New came and new inner door frame in compact microwaves ovens

MODELS

MW 32 BIS - MW 32 BIT and MC 32 BIS

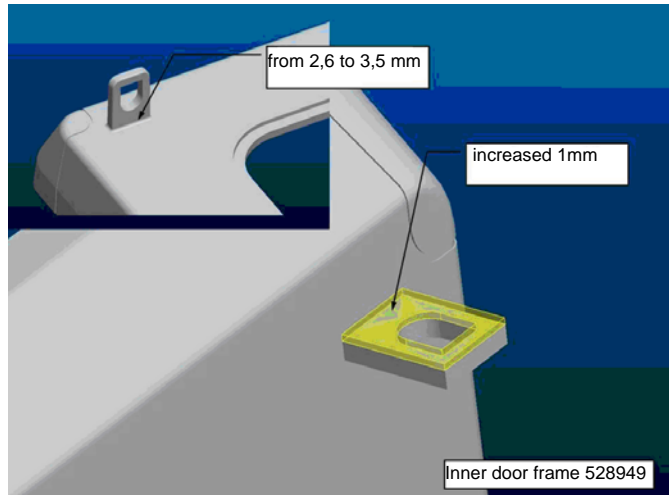
- Came turned to the safety position in a consequence of reduced inter-action between hook and came. In consequence of this fast movement were identified occurrences of spring out of position.
 - Microwave stop during normal use in consequence of instable micro switches action
1. Replace Right Came and Left Came for a new ones

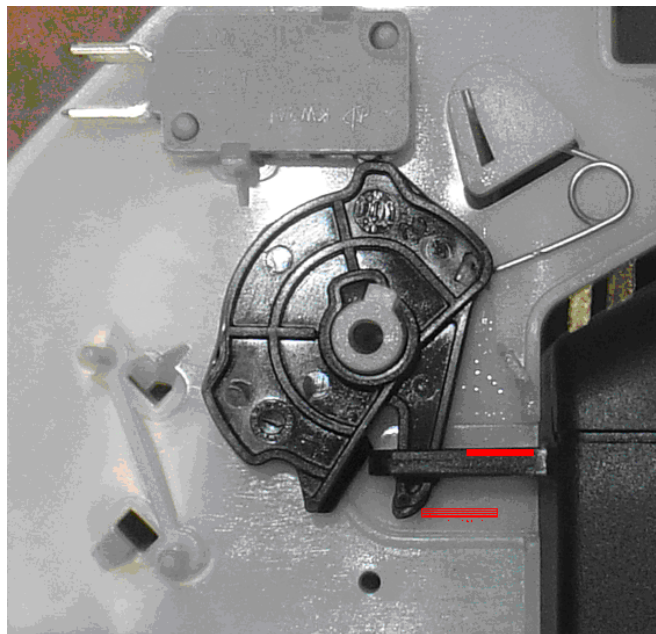
2. Replace Inner Door Frame for a new version
Thickness increased 1mm and base reinforced.

Hook configuration more strong, reducing accidental broken occurrences

With these improvements we assure an adequate mechanical action on the came resulting a good working stability. Extreme working positions will be controlled by the hook without the possibility of came returning to the safety position after hook freedom.
